**REVISED PETITION TO AMEND
THE COMMISSION'S CERTIFICATION OF THE
ABENGOA MOJAVE SOLAR PROJECT**

09-AFC-5C

October 29, 2013

Abengoa Mojave Solar Project
Mojave Solar, LLC
13911 Park Avenue, Suite 206
Victorville, CA 92392

Alpha And Beta Proposed General Arrangements

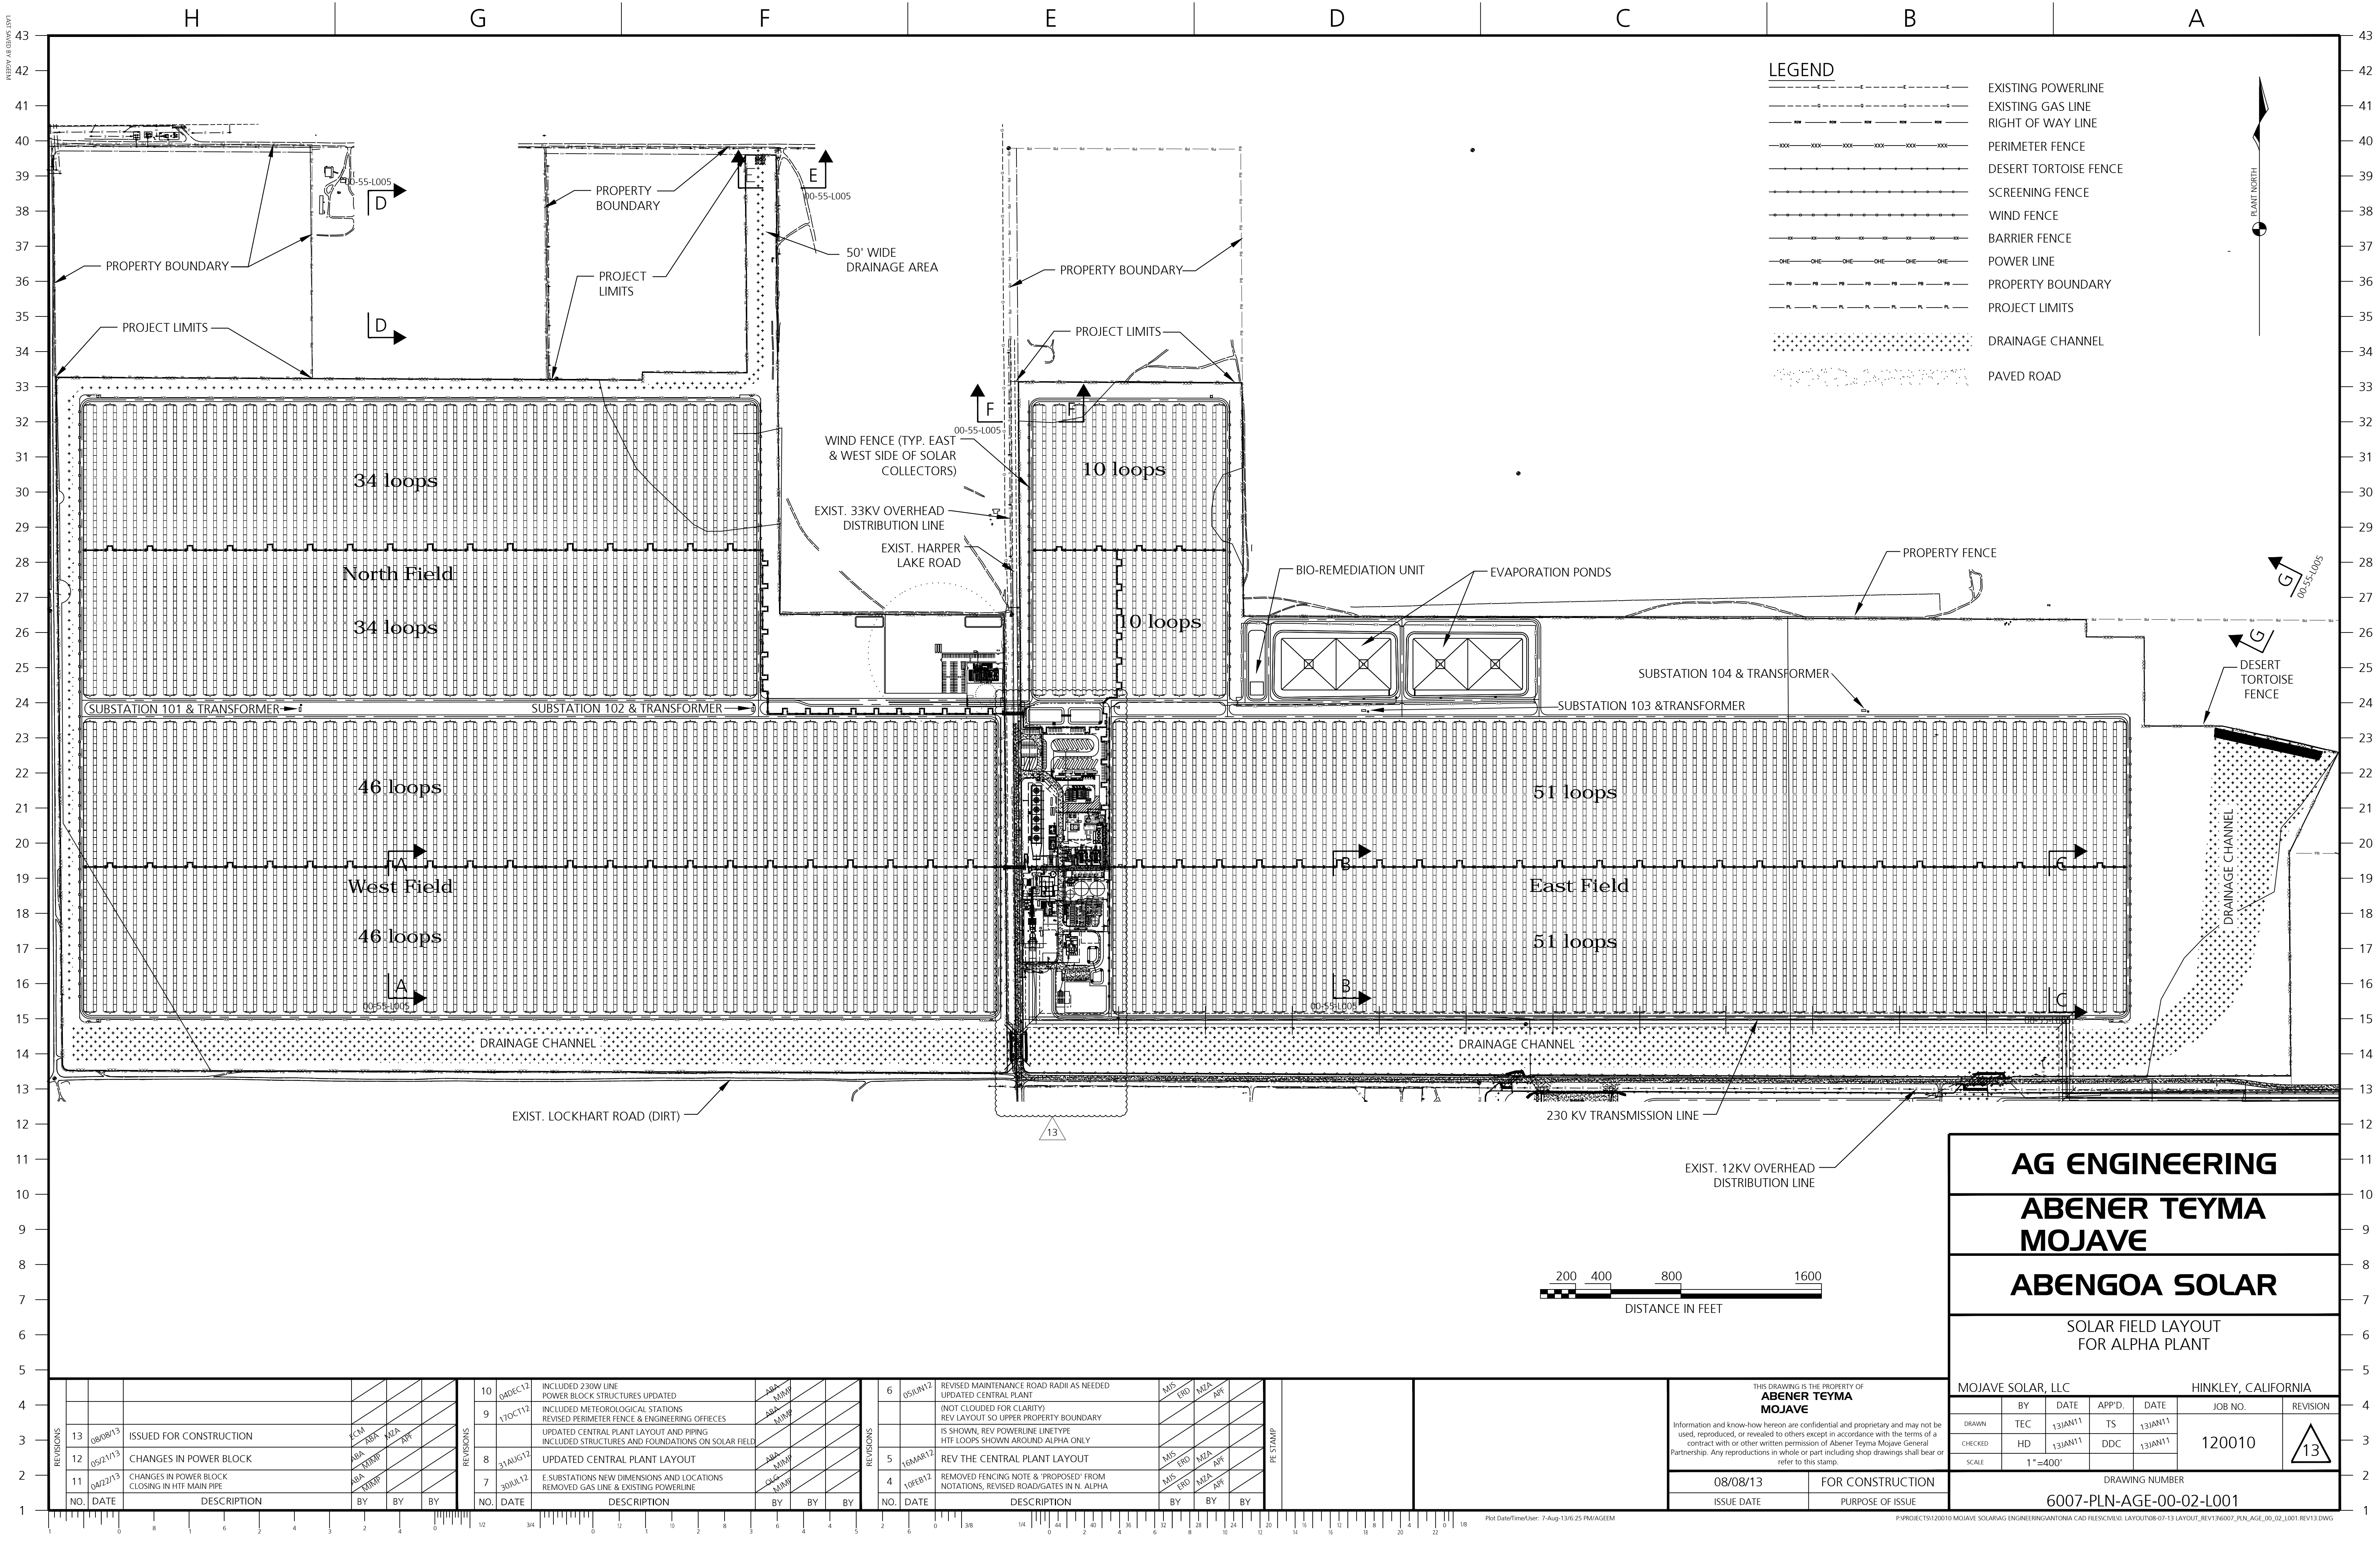
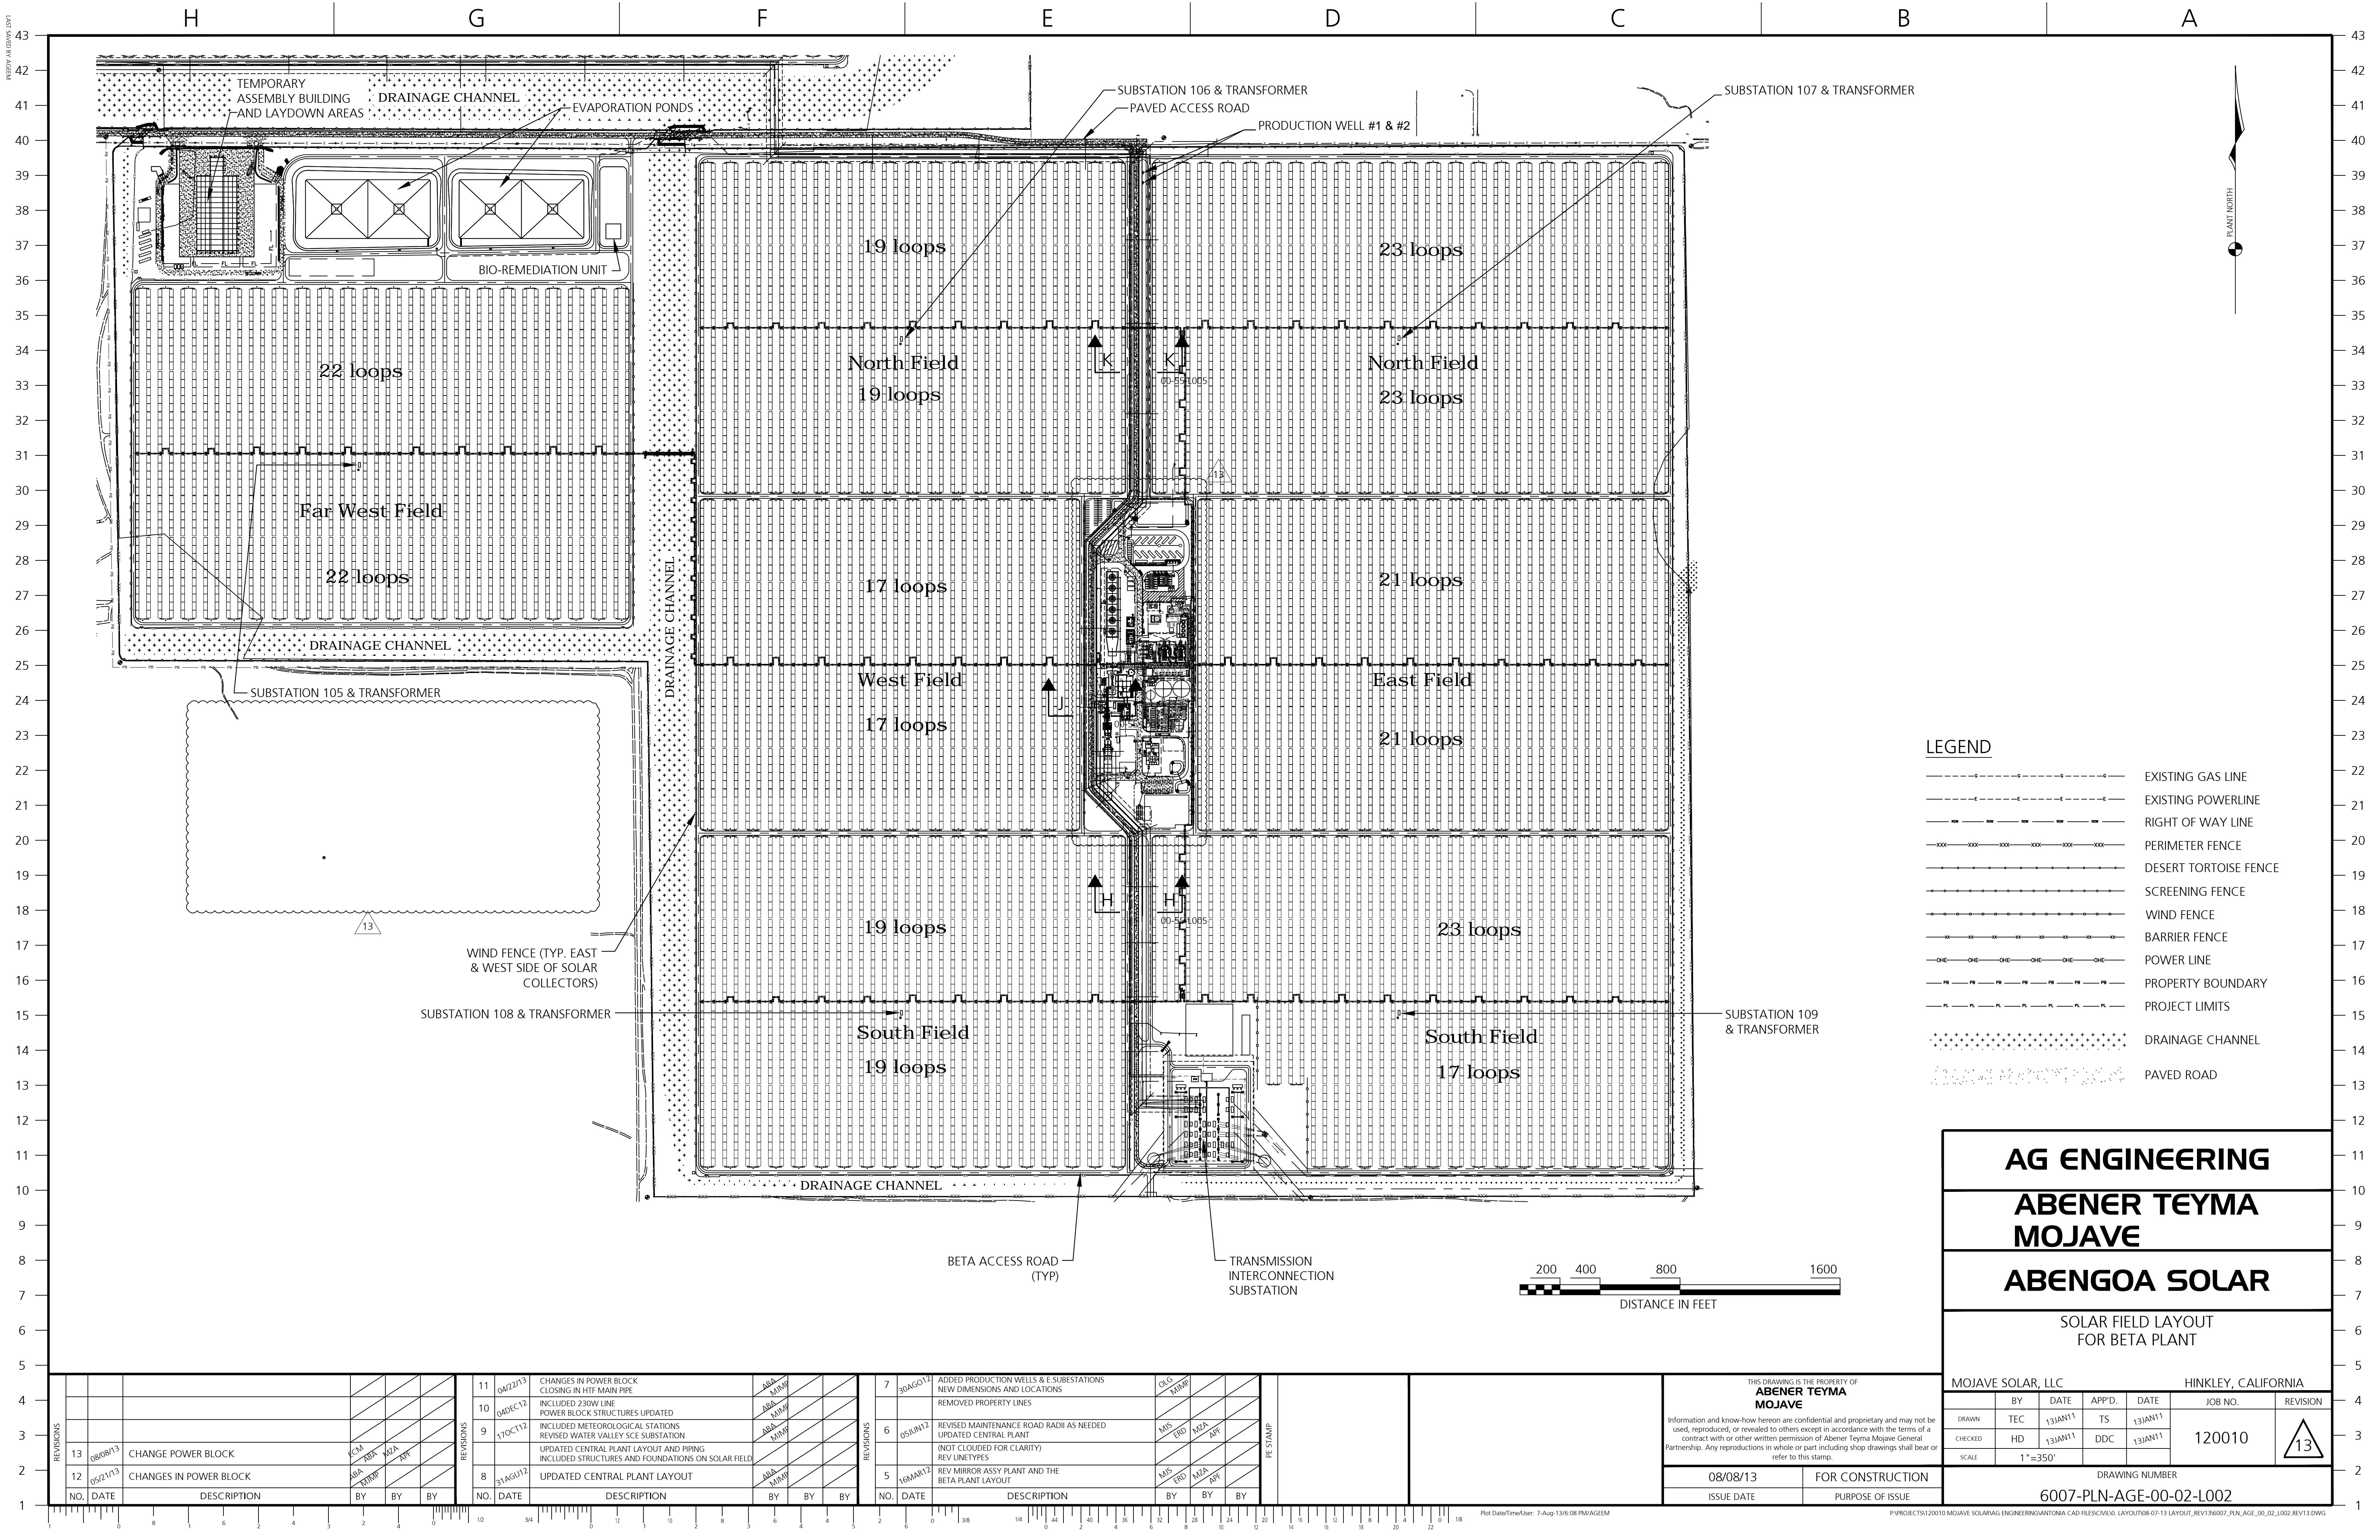
- Modifications to the MSP Project Description
 - Modifications to the general arrangement of the Alpha and Beta power blocks;
 - Remove the existing low boilers and high boilers cleaning distillation VOC control system and install a scrubbing and carbon adsorption VOC control system;
 - Update the facility component counts with revision to the fugitive emissions inventory;
 - Replace the currently permitted two (2) Tier II 4,190 hp⁵ (3,125 kW) emergency generators with two (2) Tier II 2280 kW units;
 - Reduce the currently permitted Tier II emergency generators' stack height to 30 feet above ground level (AGL);
 - Replace the currently permitted two (2) 346 hp Tier III fire pump engines with two (2) larger 575-617 hp Tier III engines; and
 - Remove the operational testing restriction of one (1) emergency engine per hour with the simultaneous testing of all emergency equipment.

The modifications to the project description are needed to reflect the changes to the MSP's general arrangement and replacement of certain equipment that has occurred during the final detailed engineering design phase for the MSP. The modifications to the conditions of certification are needed to conform the conditions to the proposed changes to the project description.
